Preview Solution CBR-2540-5

Upper Bunk Restraint System – Plastic Gable Retention Field Fix

Published 15 January 2026

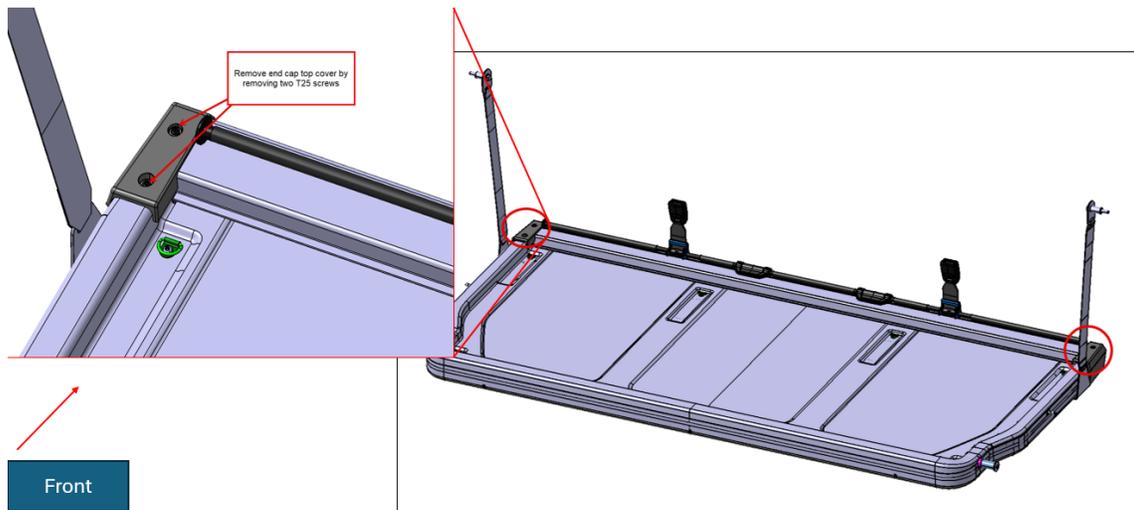
- Plastic gables are visible through the curtain slot opening. Access and visibility are achieved through this opening; removal of additional trim is not required.

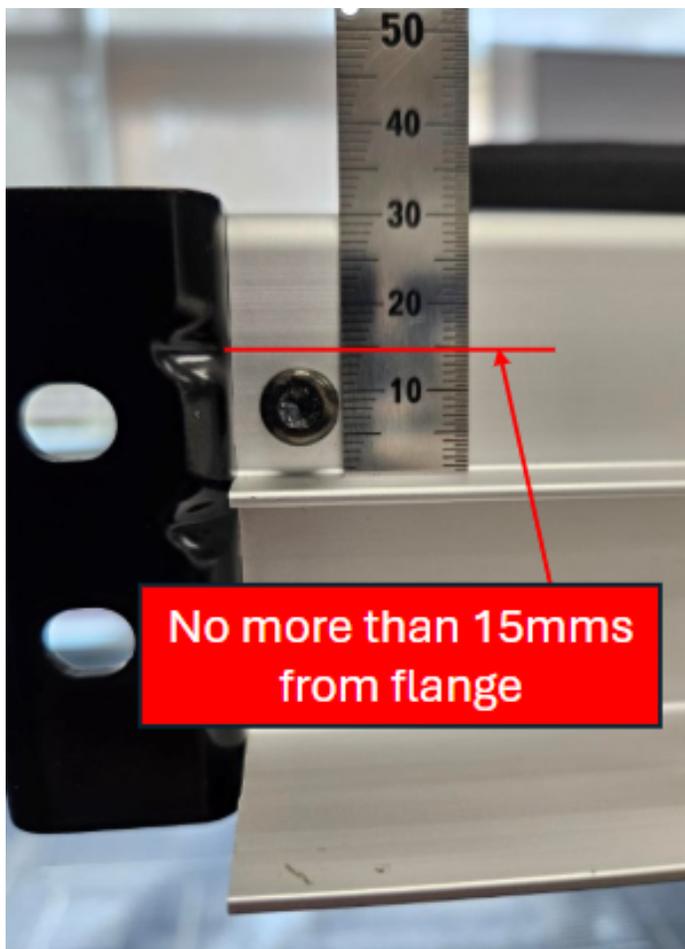
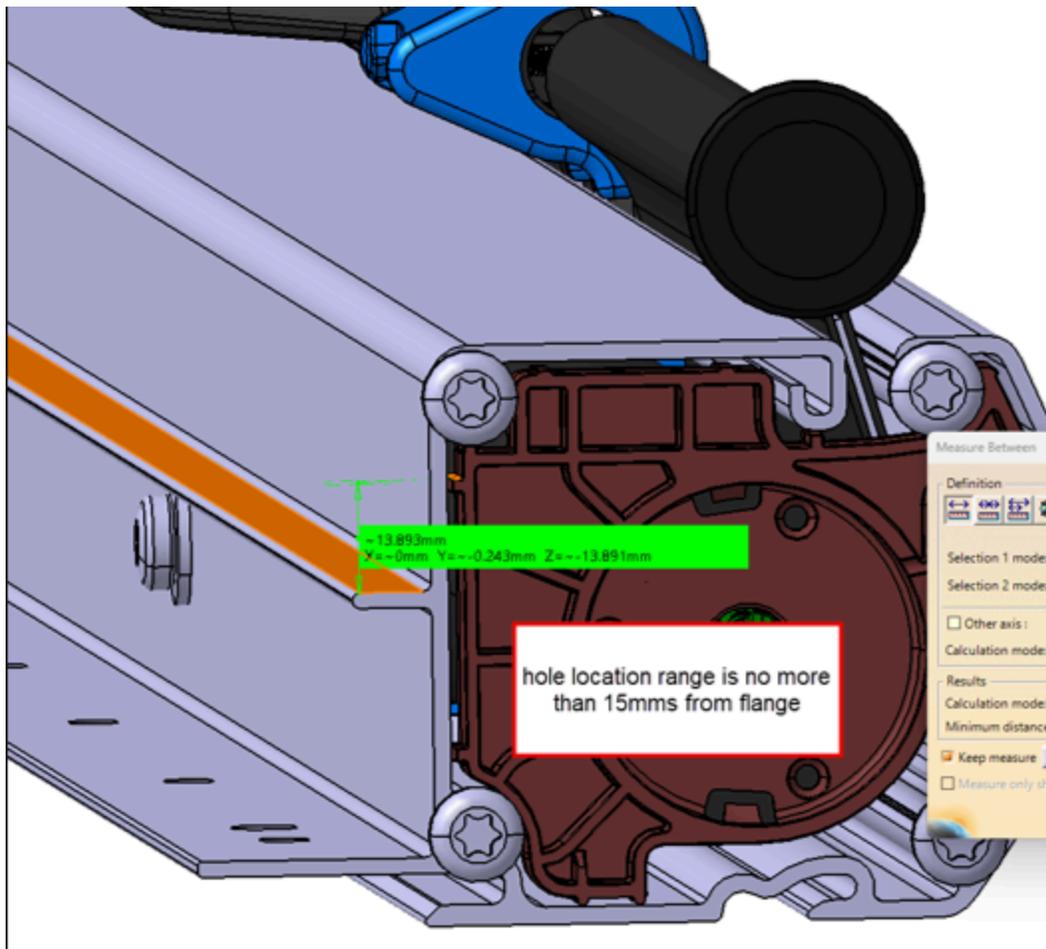
- Remove LH and RH top portions of end caps and retain for reinstallation.

Cross-sectional view indicating the required screw fastening locations.

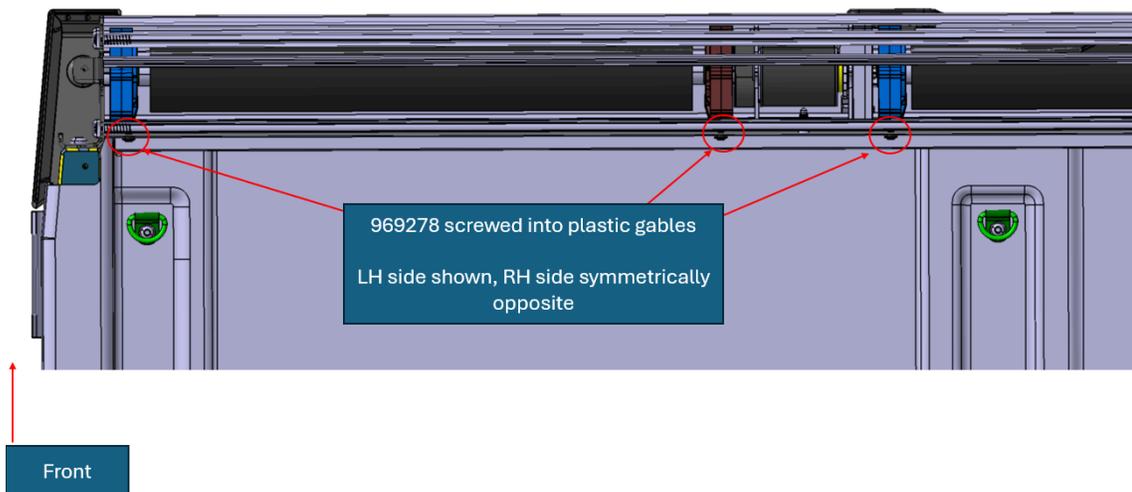
- Mark centerline of each plastic gable using masking tape.
- Measure approximately 15 mm from the back flange of the restraint. Do not exceed this measurement.
- Drill pilot hole if needed (do not exceed 1/8 in bit).
- Work from one end to the opposite end to prevent gable shift.

- Drill through aluminum restraint and plastic gable.
- Maximum drill depth: 0.5 in.
- Install screw 969278 into each plastic gable.
- LH side shown; RH side is symmetrical.

After field fix containment solution 3 out of 6 screws
LH side shown RH Side symmetrically opposite
